# Access Compliance Report

## Public Rights-of-Way

Intersection ID: 45501	Main Street: BUGGY_HORSE_RD	Cross Street: CAPTAIN_ARDREY_RD	Location: E
ADA ID: AF2E57D967A0	Ramp Type: PerpDiag	Initial Pass/Fail: Fail	Overall Compliance: No
Severity Score: 22.5			
Codes/Mitigation Info/Possible Solution		Field Measurements/Component Compliance

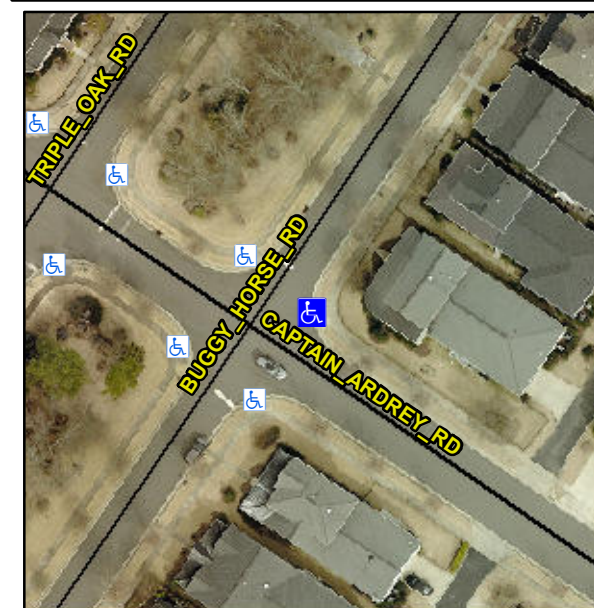
**Not Found, R304.5.1, R304.2.2, R304.5.3**

Compliance	Description	Data	Compliance	Description	Data
N/A	Ramp Length (in)	72.0	No	Ramp Slope (%)	11.4
No	Ramp Width (in)	36.0	No	Ramp XSlope (%)	5.0
N/A	Flare Type LT	N/A	N/A	Flare Type RT	N/A
N/A	Flare Slope LT (%)	N/A	N/A	Flare Slope RT (%)	N/A
N/A	Flare Traversable LT?	N/A	N/A	Flare Traversable RT?	N/A
N/A	Landing Length (in)	N/A	N/A	DWS Provided?	N/A
N/A	Landing Width (in)	N/A	N/A	DWS Contrast?	N/A
N/A	Landing Slope (%)	N/A	N/A	DWS Length (in)	N/A
N/A	Landing X Slope (%)	N/A	N/A	DWS Full Width?	N/A
N/A	Landing Curb? (Y/N)	N/A	N/A	DWS Offset (in)	N/A
N/A	Shared Landing?	N/A			
N/A	Gutter Ponding?	N/A	N/A	Gutter Slope (%)	N/A
N/A	Gutter Lip Ht (in)	N/A	N/A	Gutter X Slope (%)	N/A
N/A	Painted X Walk1?	No	N/A	Painted X Walk2?	No
	X Walk 1 Direction	To NW		X Walk 2 Direction	To SW
N/A	X Walk 1 Width (in)	N/A	N/A	X Walk 2 Width (in)	N/A
	X Walk 1 Slope (%)	2.3		X Walk 2 Slope (%)	3.4
	X Walk 1 X Slope (%)	4.0		X Walk 2 X Slope (%)	3.3

**Remove & Replace Curb Ramp With Two New Directional Ramps or Equivalent.**
